ADDENDUM NO. 1

Date: **February 9, 2024**
Issued by: **Sacramento City Unified School District**
Project: **Project #0410-409-1 Albert Einstein MS Modernization**

PLUMBING ENLARGED BOYS LOCKER ROOM ALTERATION PLAN

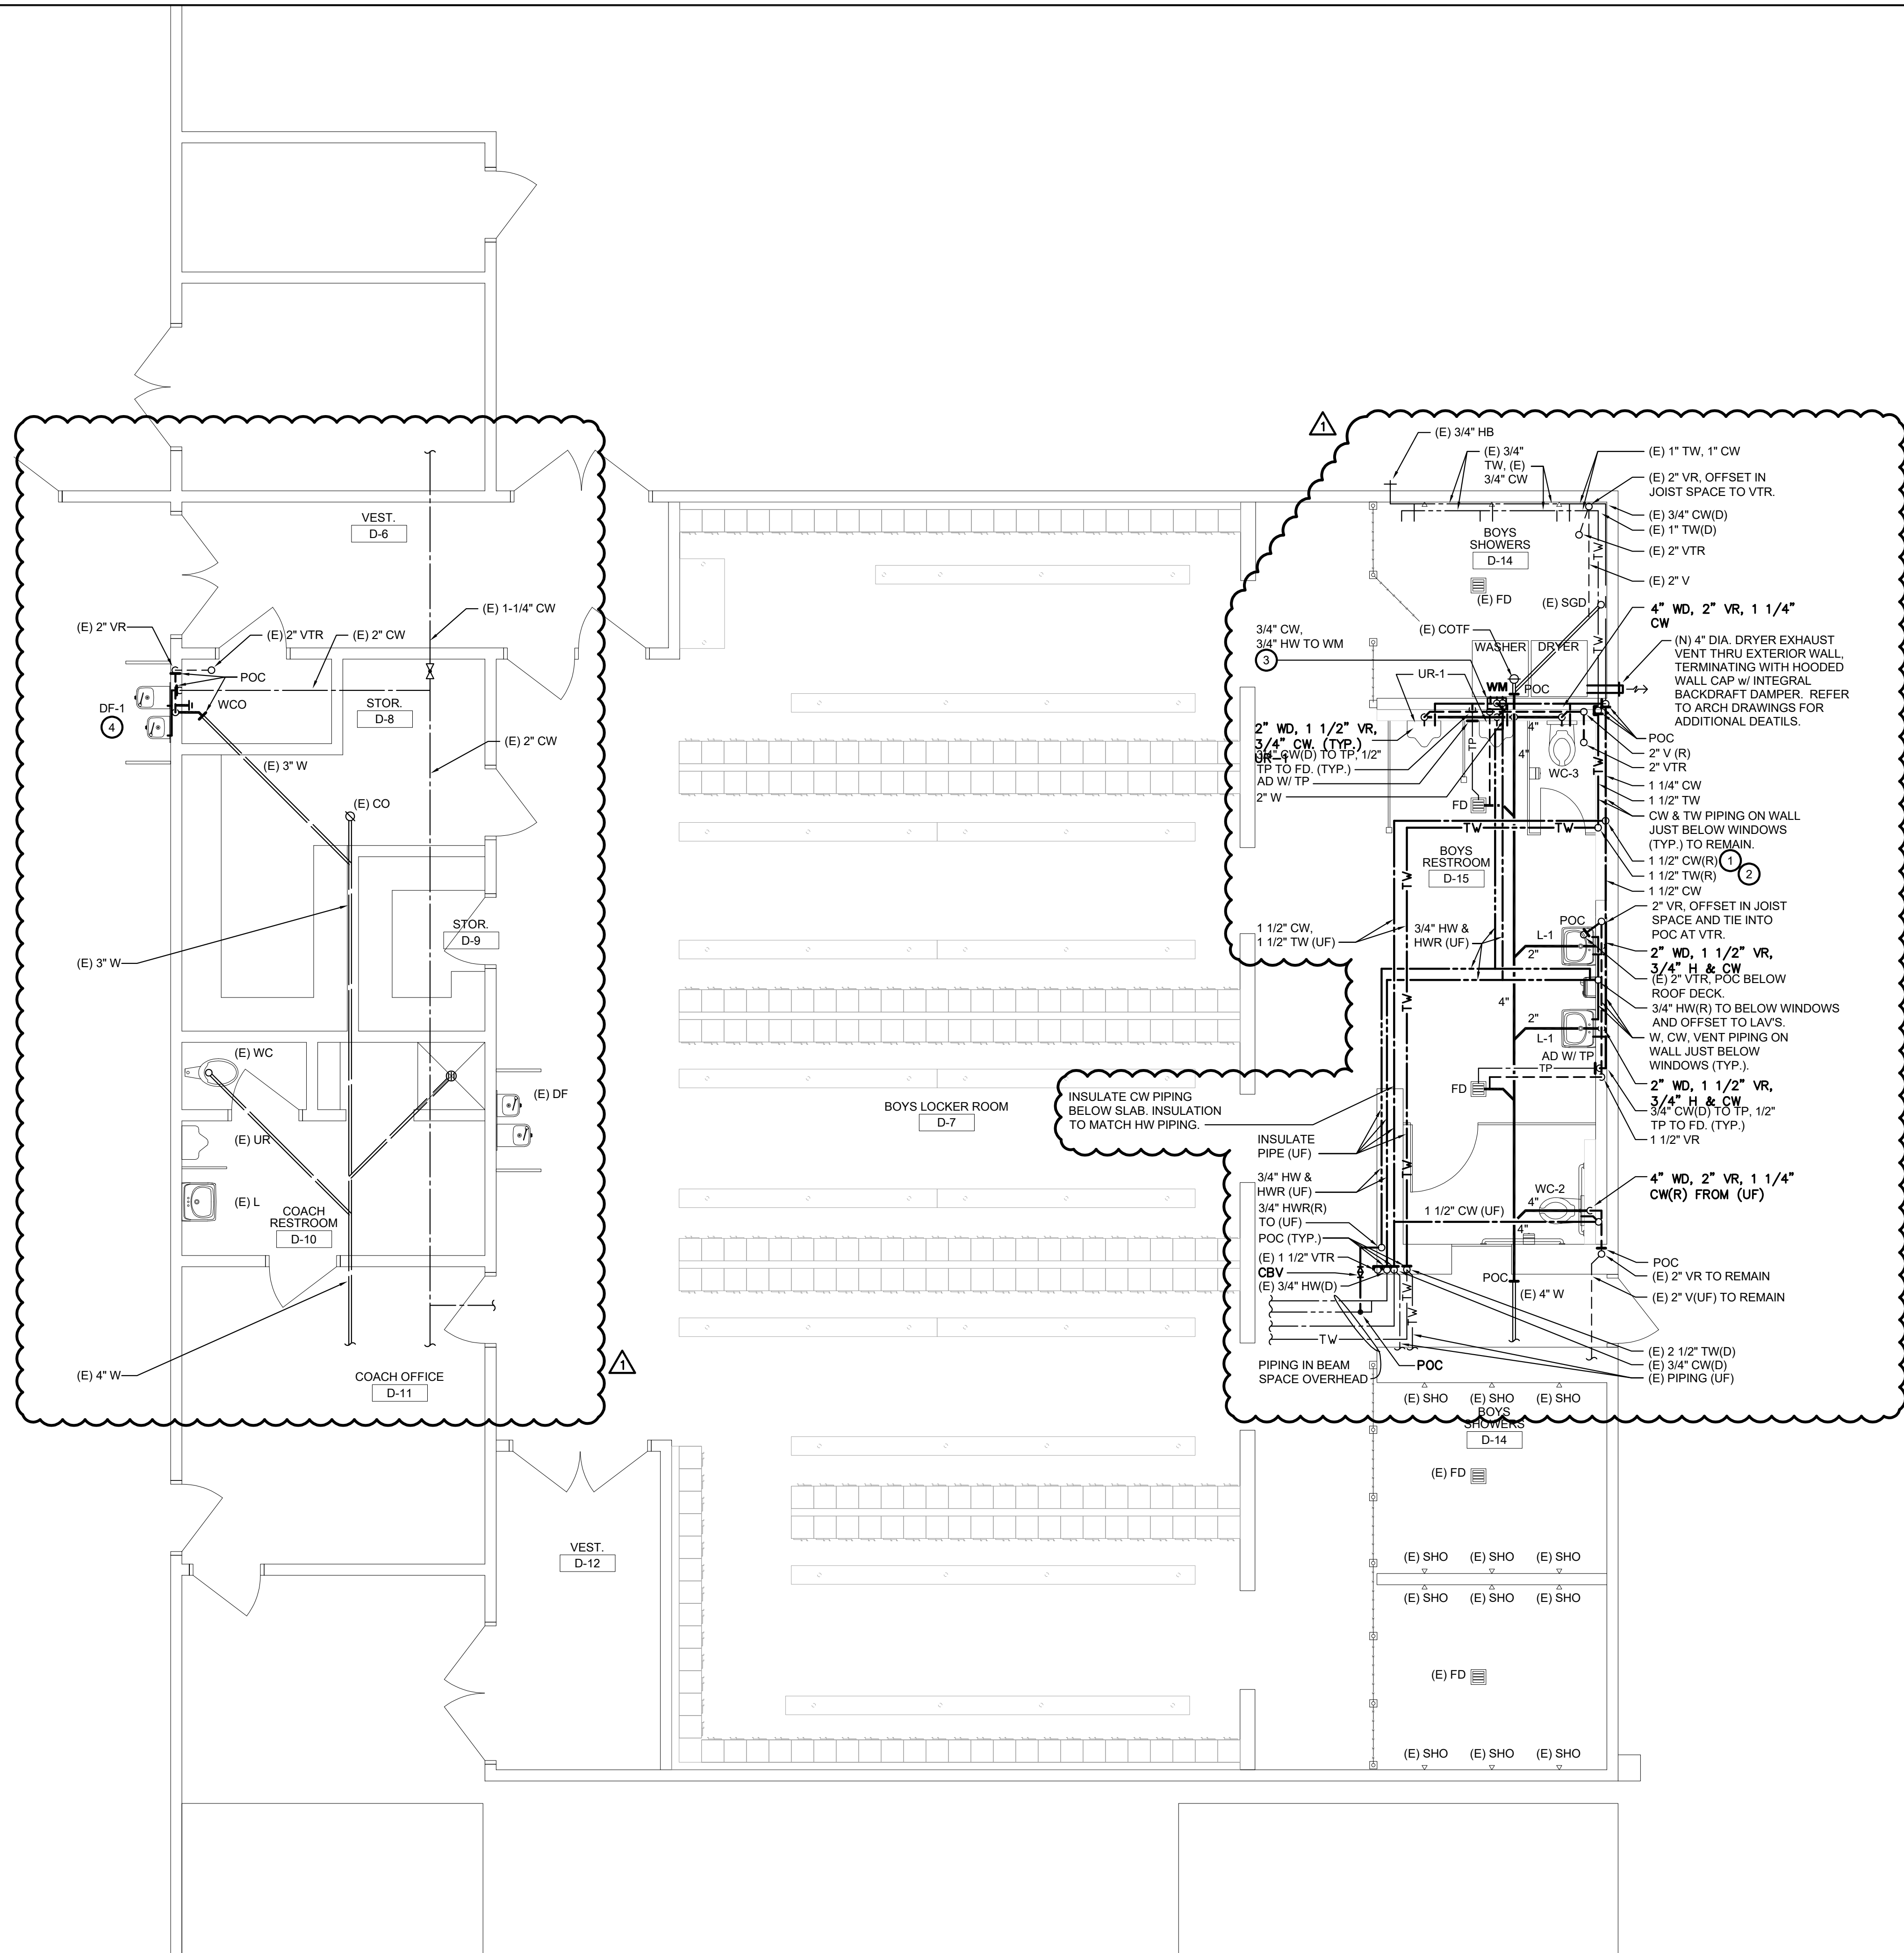
Addendum Item No. AD1.24 - P423 Plumbing Enlarged Boys Locker Room Alteration Plan (Package A)

- Replace sheet in its entirety per addendum drawing number AD01.24. Revised amount of new piping and routing as shown.

Q#8: Bid Package A – Sheet P423 – P423 does not provide sheet notes for Boys Restroom denoting fixture relocation, POCs, existing water sizing. Confirm floor drains and trap primers are existing and not to replace.

Q#11: Bid Package A – Sheet P423 – P423 shows a new DF-1 on floor plan. No plumbing utilities are shown to this new fixture location.
R#11: *Per discussion with CECI – See updated plans AD01.24 for piping in this area.*

Q#12: Bid Package A – Sheet P423 – Please advise if new DF-1 wall install at this location. If yes, please provide plumbing design and routing for waste, vent, water, and power.
R#12: *Per discussion with CECI – See updated plans AD01.24 for piping in this area.*

R#8: *Per discussion with CECI – See updated plans AD01.24 for piping in this area.*

PLUMBING
 ENLARGED
 KITCHEN
 DEMOLITION PLAN

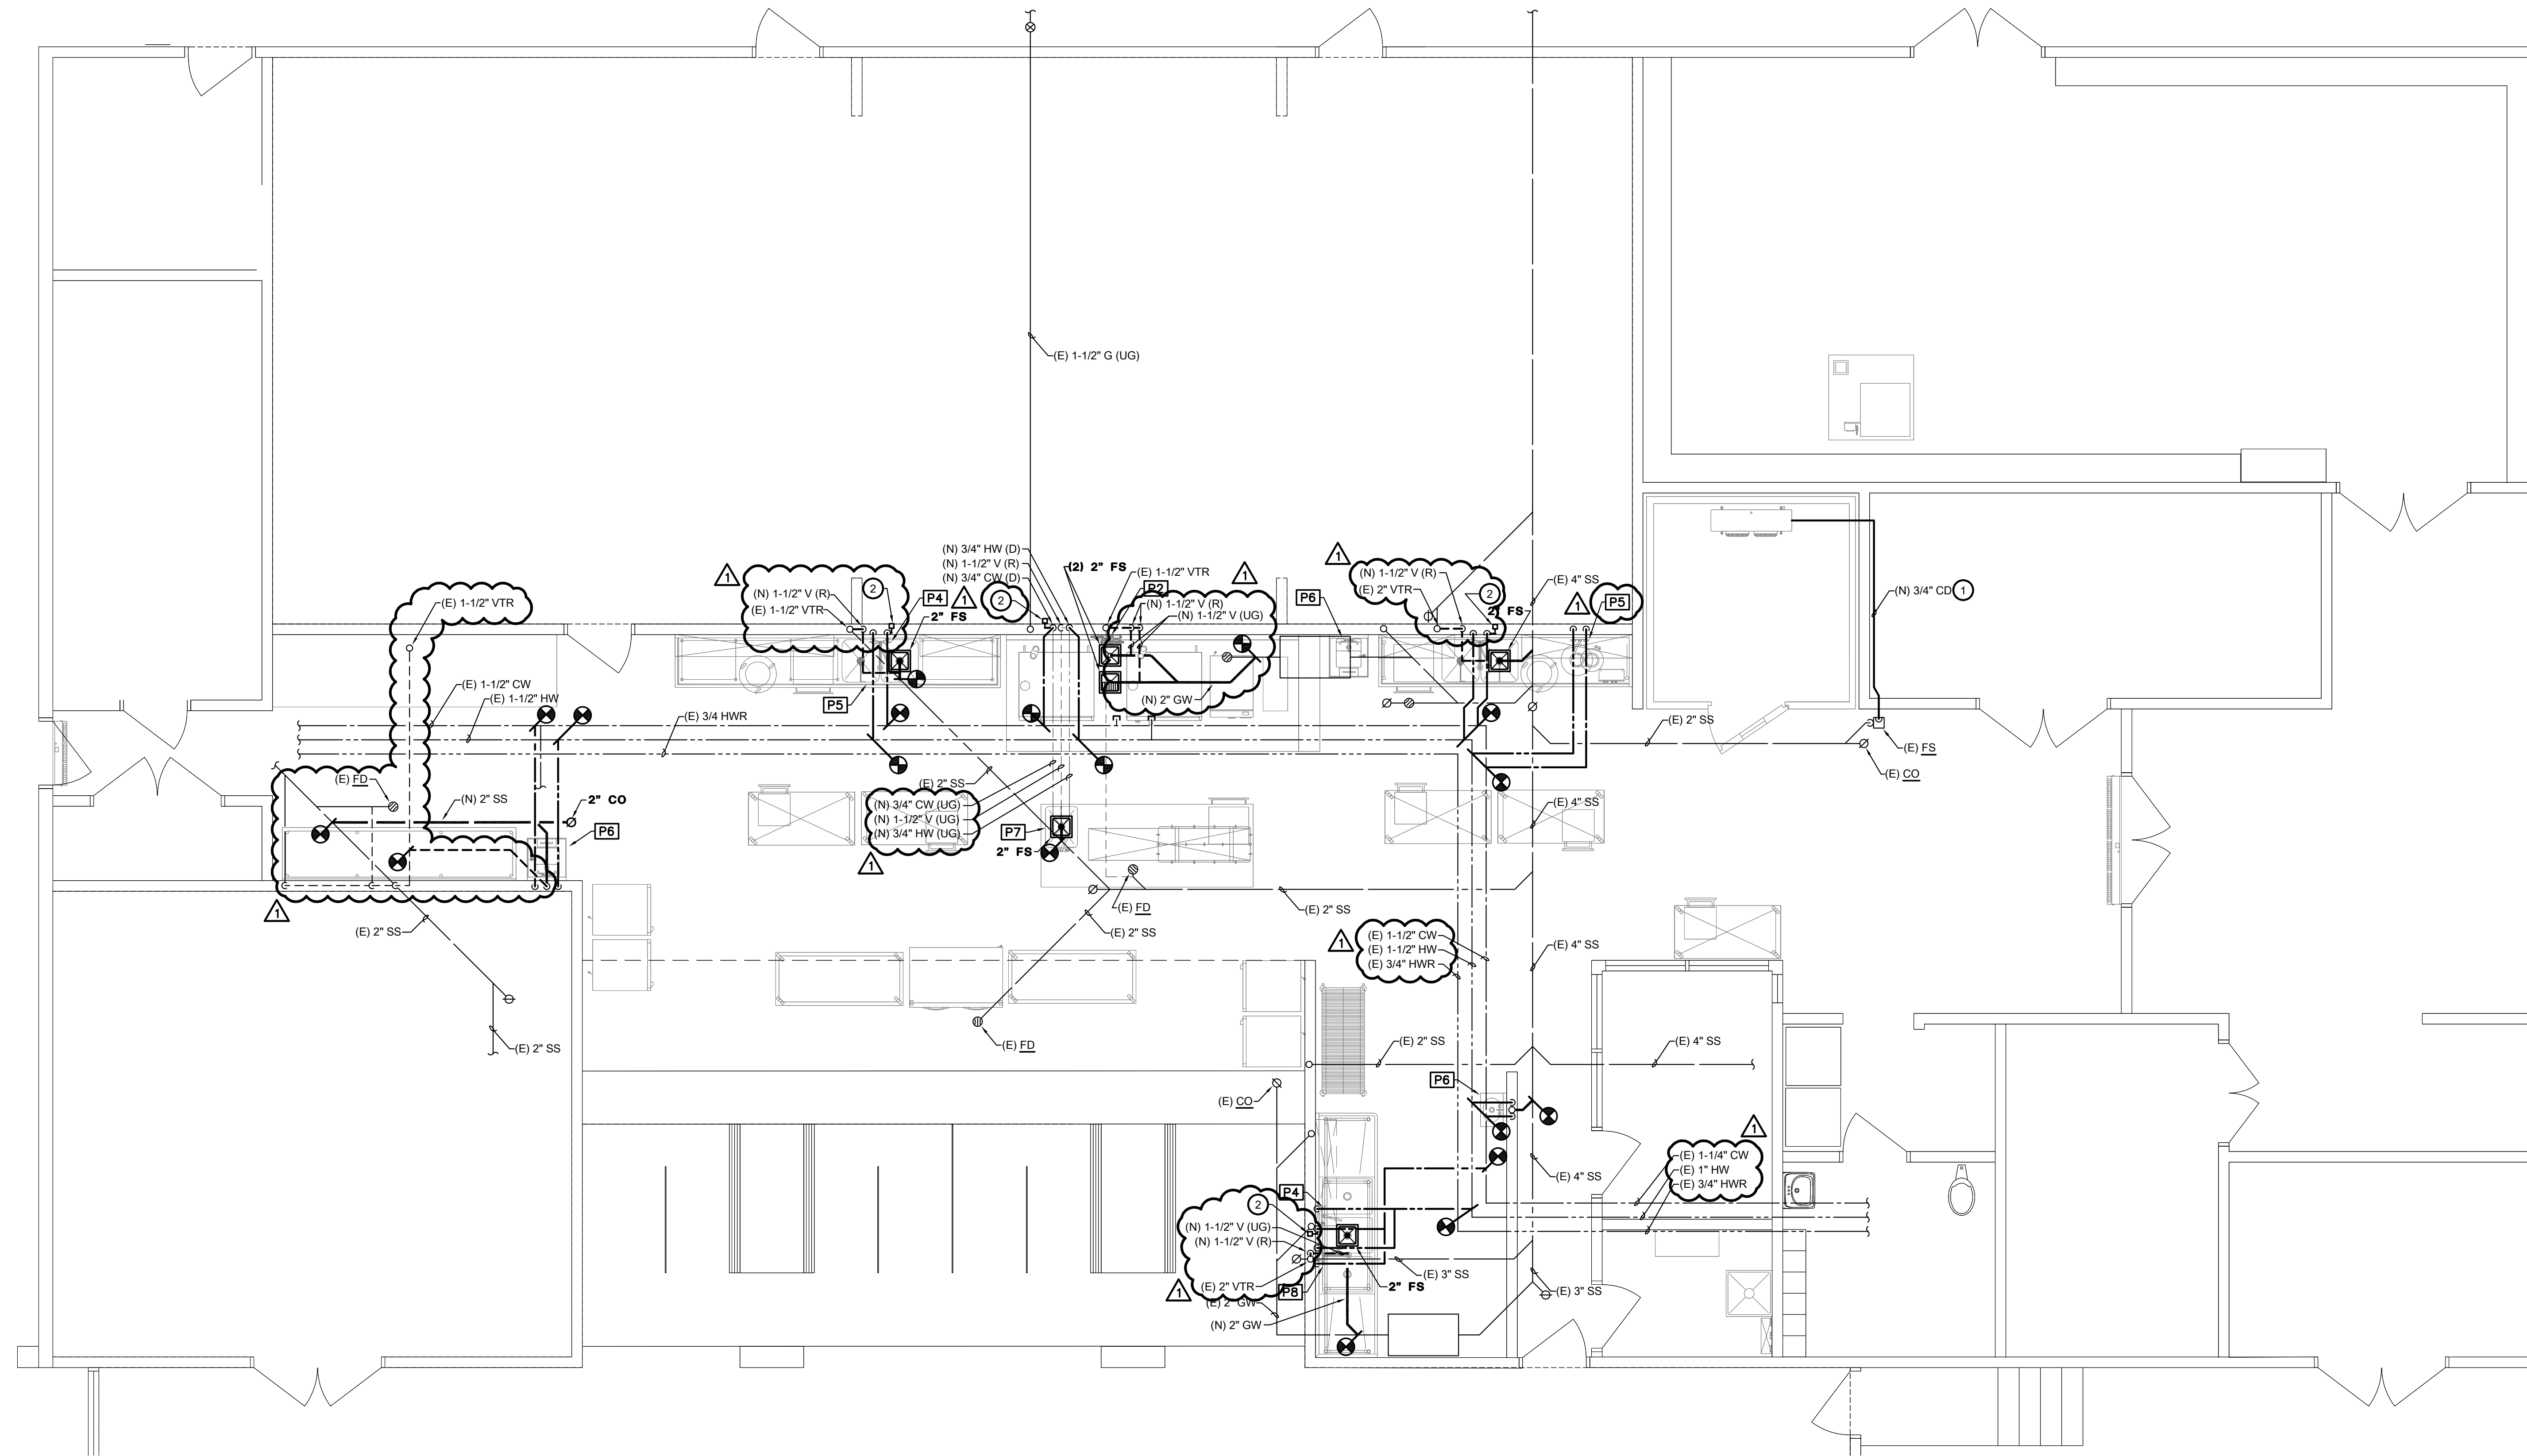
Addendum Item No. AD1.25 - P430 Plumbing Enlarged Kitchen Demolition Plan (Package A)

- Replace sheet in its entirety per addendum drawing number AD01.25. Revised extent of demolished piping as shown.
